IloT Product End-of-Life Notice

End of Life, Last Time Buy and Replacement Announcement

End of Life Product	Suggest Replacement Product	Sample Available Date
ADAM-4050-E	ADAM-4050-F	Available in 2022/06/01

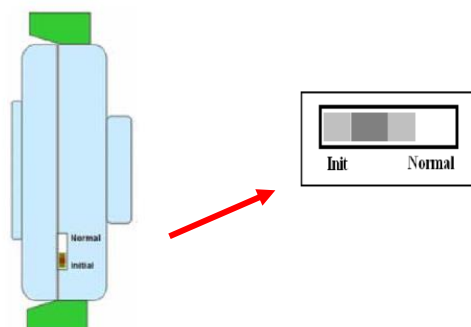
Replace the key component TI MCU 1400006109-01(MSP432P401MIRGCR) with new MCU, due to MSP432P401MIRGCR L/T is longer than 371 days.

Impact	New version
Pin assignment	Change INIT* pin to DI channel 7
Hardware spec	Add Initial switch, Change from 7 DI to 8 DI
FW	New version A 4.01 or later
Utility	Adam/Apax .NET Utility 2.6.00 B15 later version

1. Change INIT* pin to DI channel 7

2. Add Initial switch

1. Add one DI channel 7
2. Enable data format settings (parity none/odd/even, stop bit 1/2) for ADAM ASCII protocol
